STREET A PLAN AND
PROFILE

PARKER RIDGE
82 SCHOOL STREET
ROLESVILLE / NORTH CAROLINA / 27571

08/01/2023 PER TOWN OF ROLESVILLE COMMENT

LONG MELFORD DRIVE
STA: 32+50.00 TO STA: 40+00.00

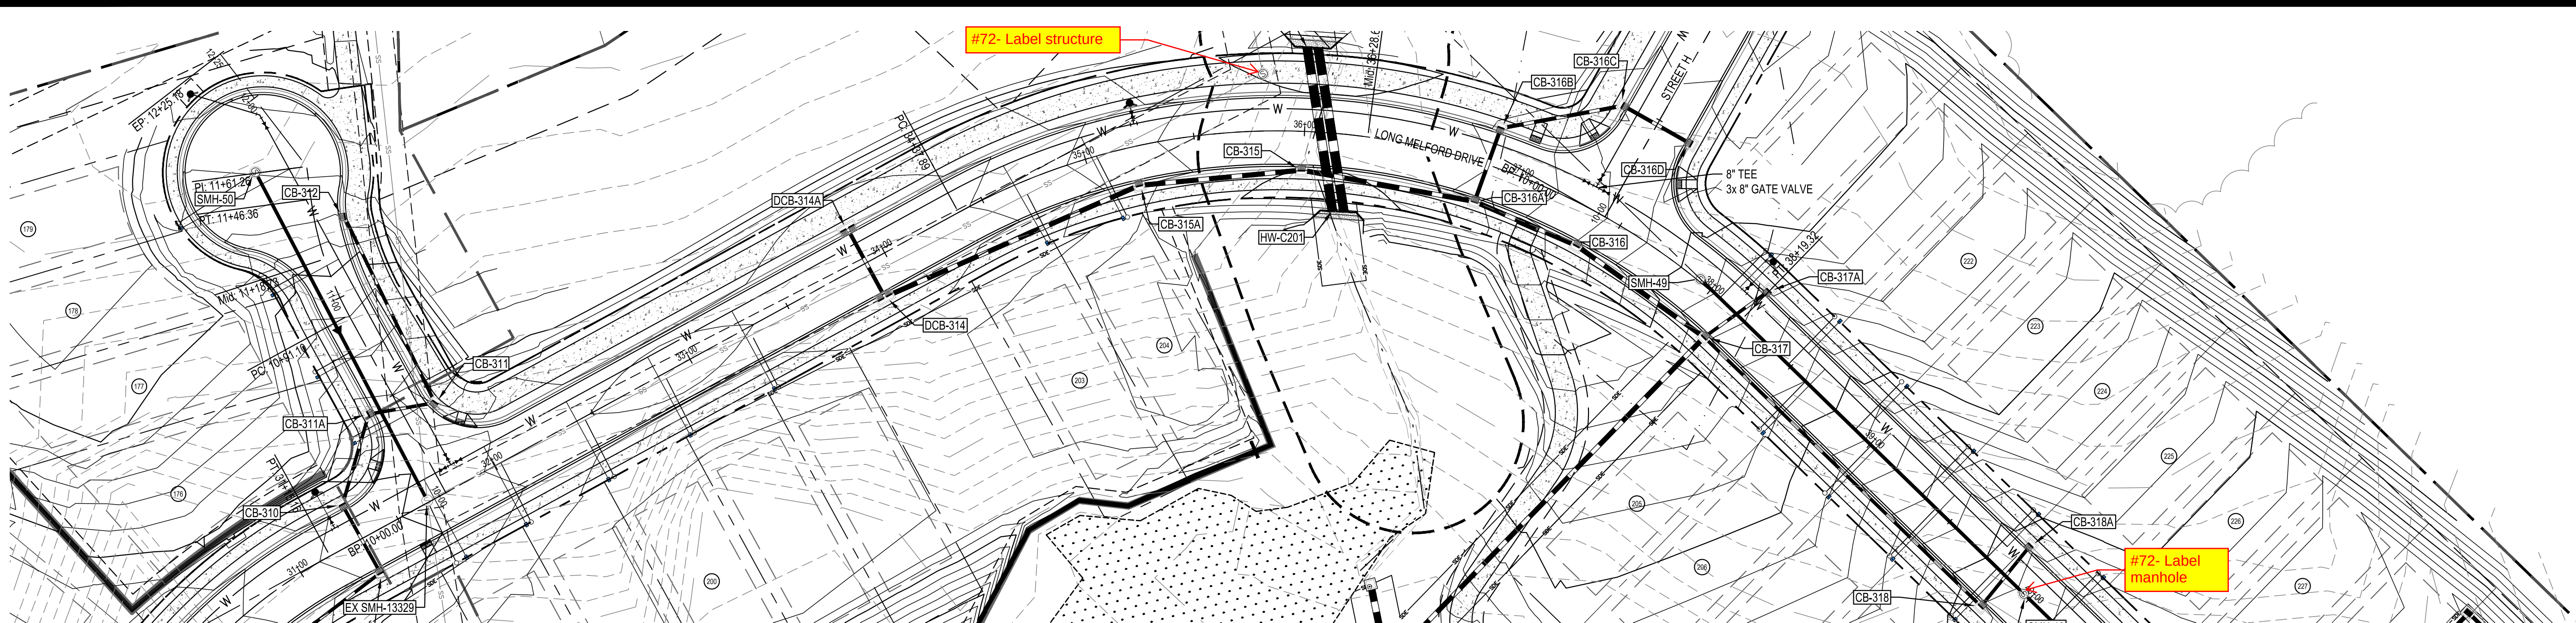
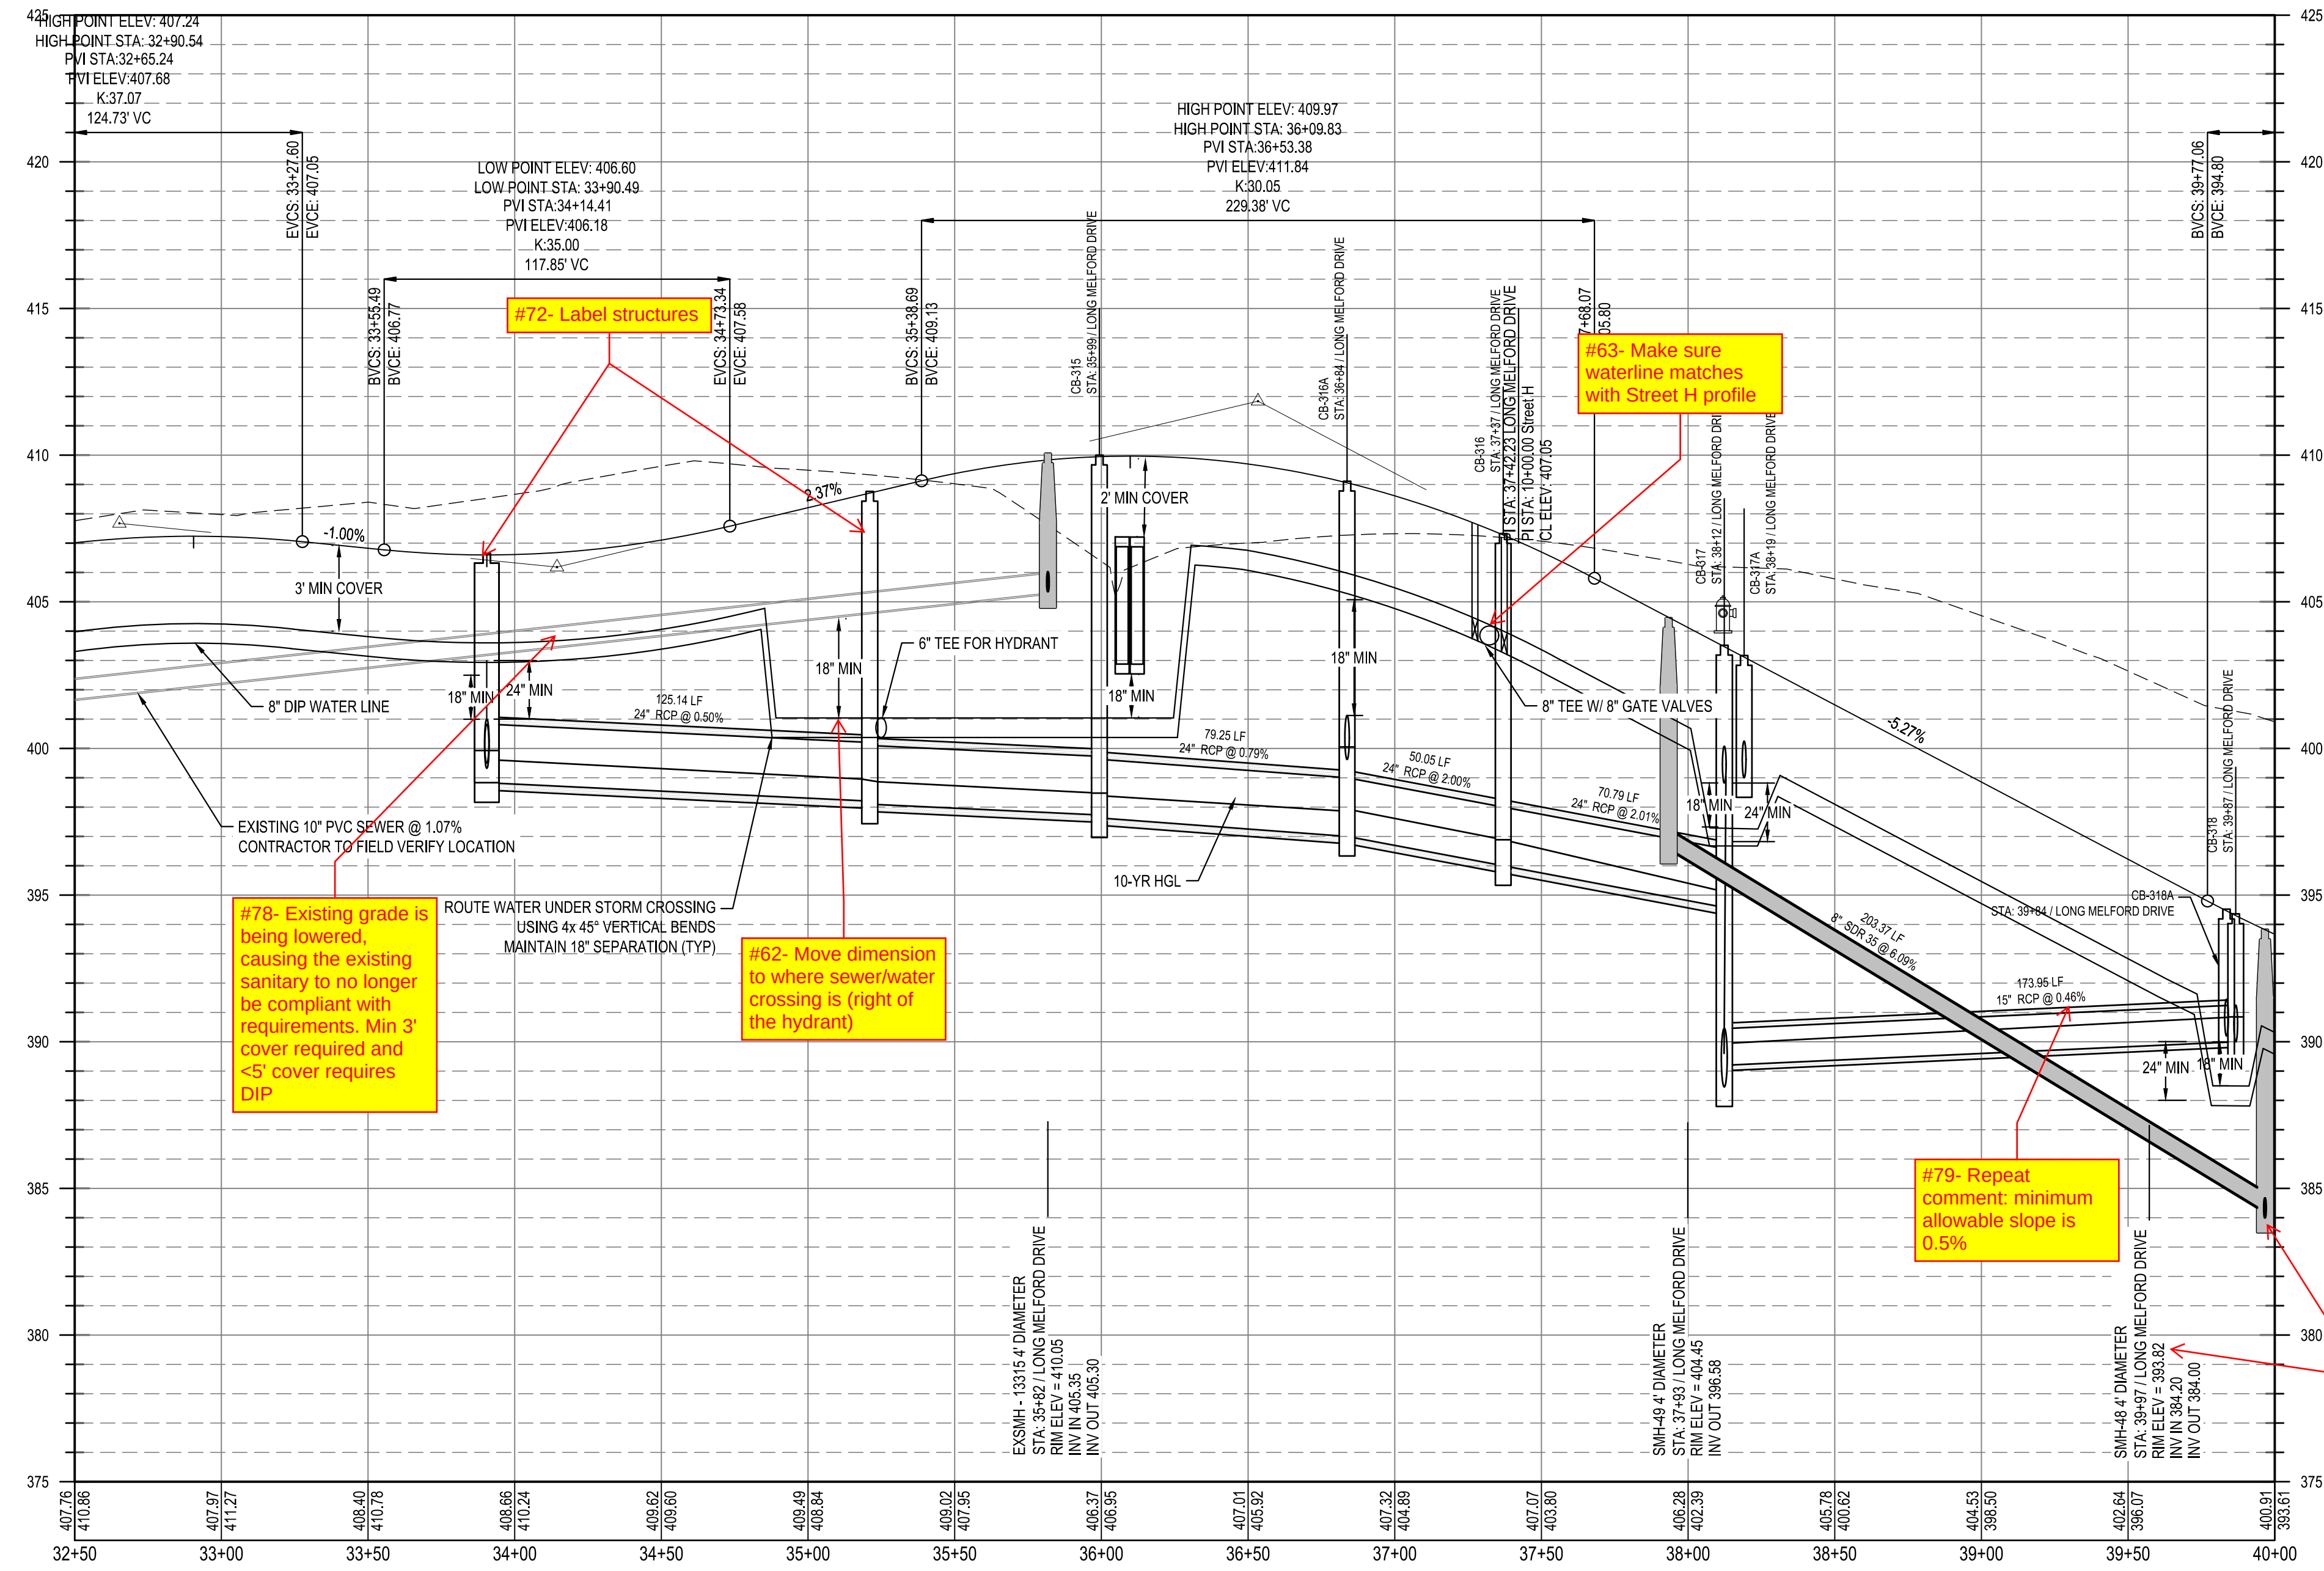
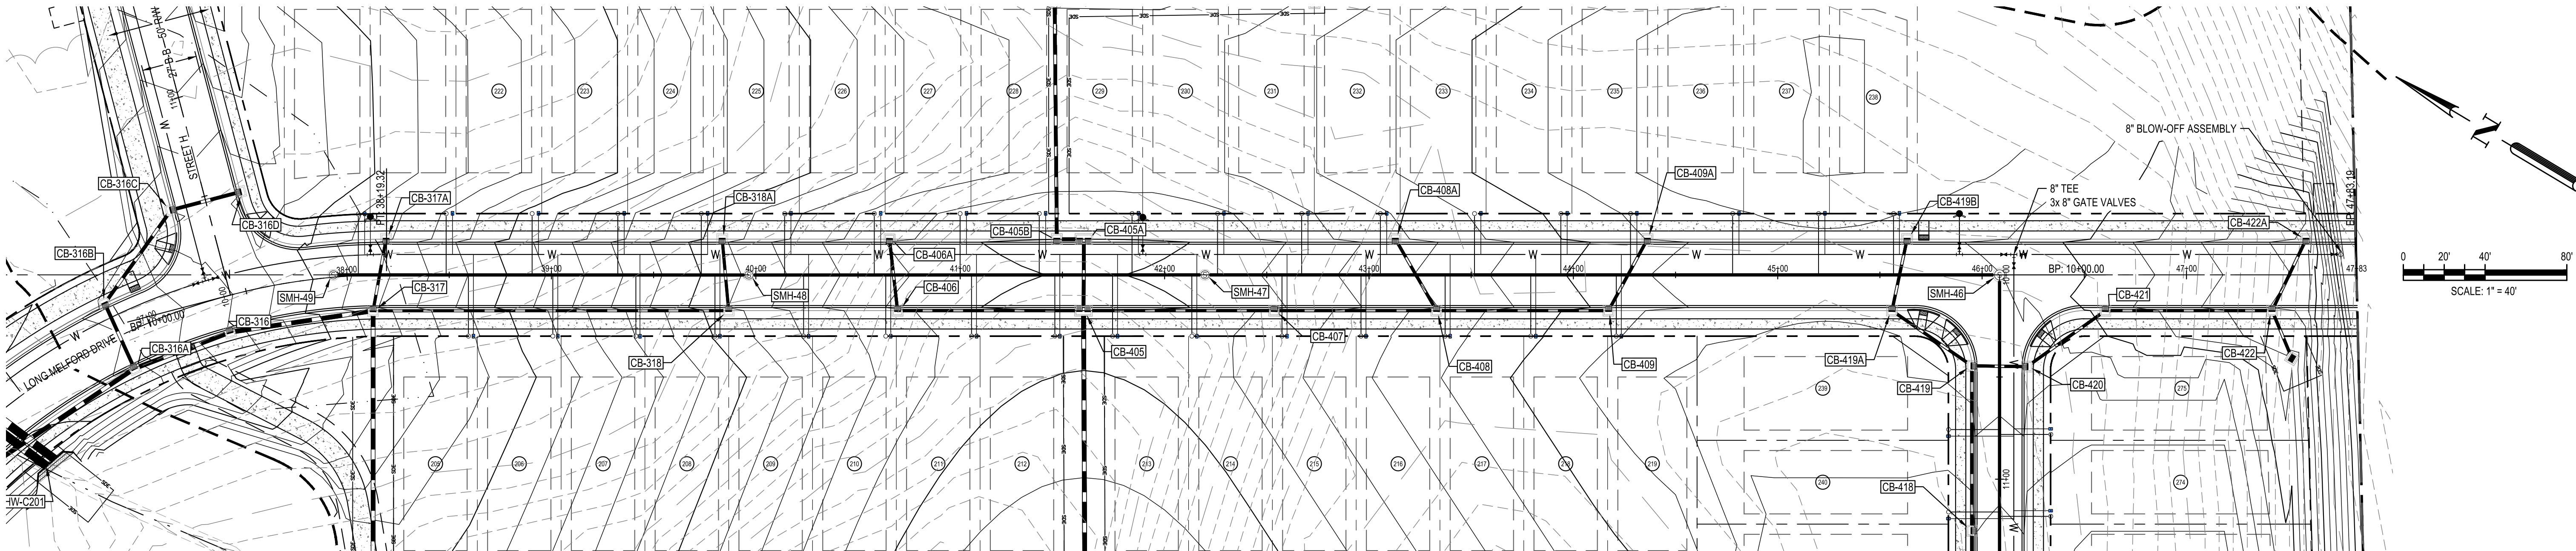
#62- There are several locations where the dimensions don't seem to line up with top/bottom of pipes. Please make sure it is clear what is being dimensioned. If crossings are not meeting minimum requirements, design will need to be adjusted.

#63- Make sure waterline matches with Street H profile

#78- Existing grade is being lowered, causing the existing sanitary to no longer be compliant with requirements. Min 3' cover required and <5' cover requires DIP

#62- Move dimension to where sewer/water crossing is (right of the hydrant)

#79- Repeat comment: minimum allowable slope is 0.5%

#72- Label should clearly point to manhole

ALLEY 1 PLAN AND PROFILE

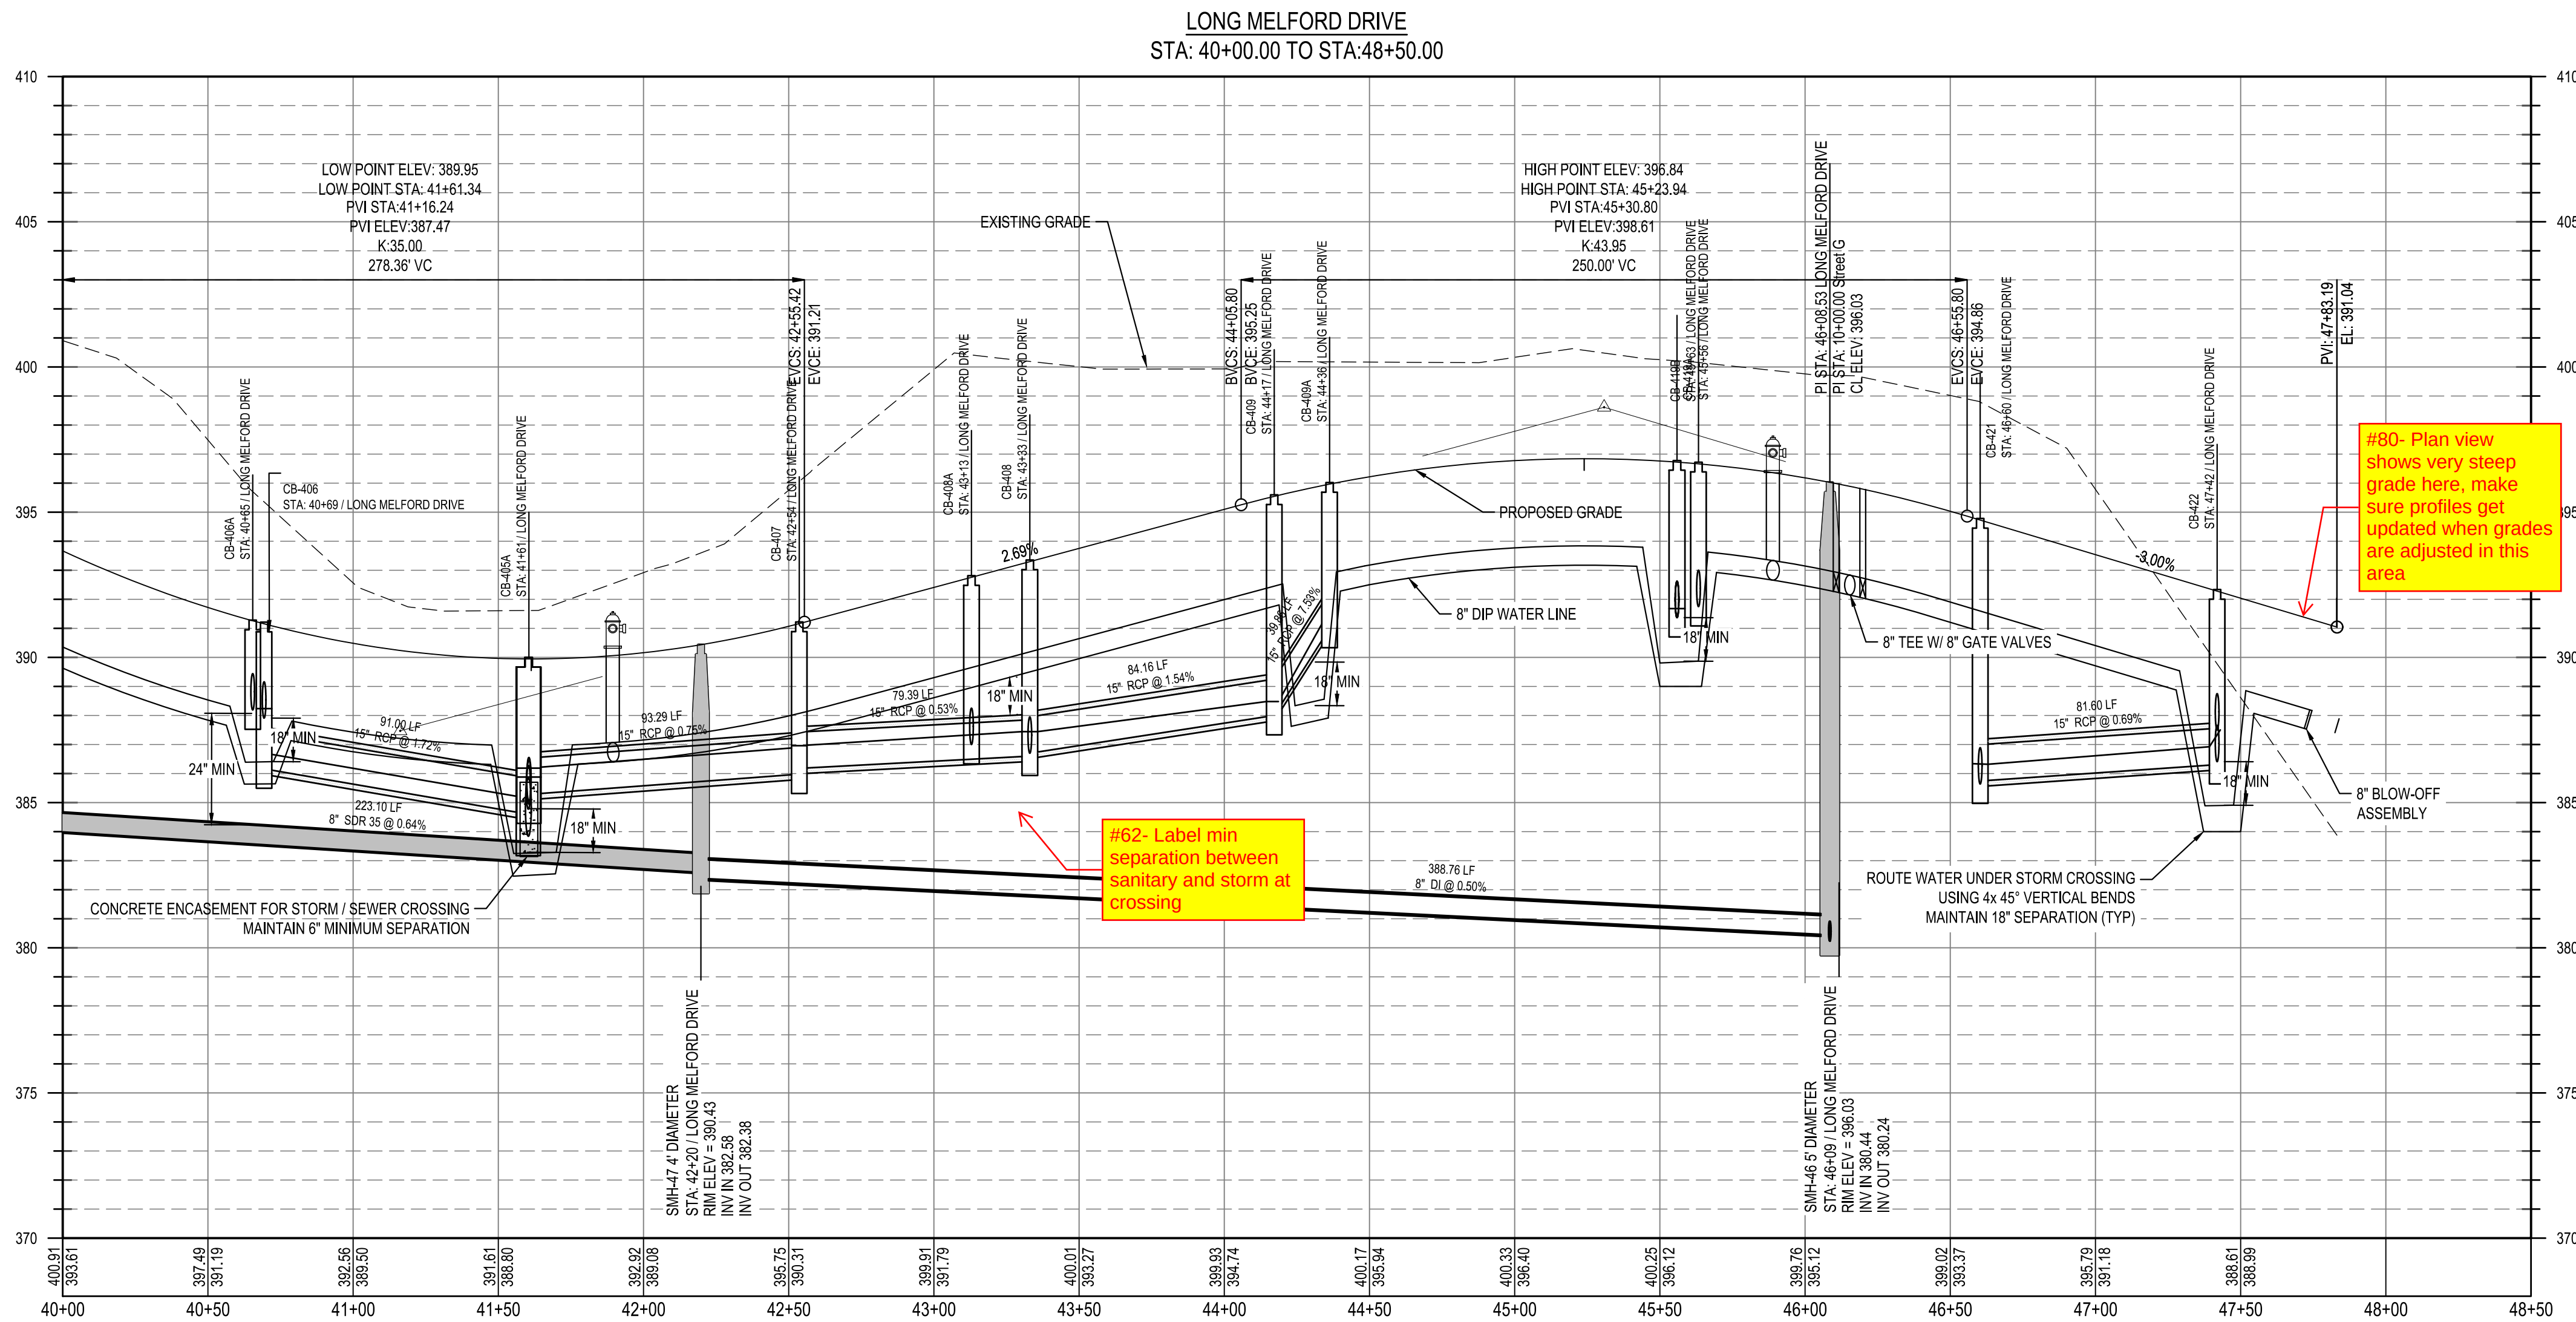
#62- There are several locations where the dimensions don't seem to line up with top/bottom of pipes. Please make sure it is clear what is being dimensioned. If crossings are not meeting minimum requirements, design will need to be adjusted.

#80- Plan view shows very steep grade here, make sure profiles get updated when grades are adjusted in this area

#62- Label min separation between sanitary and storm at crossing
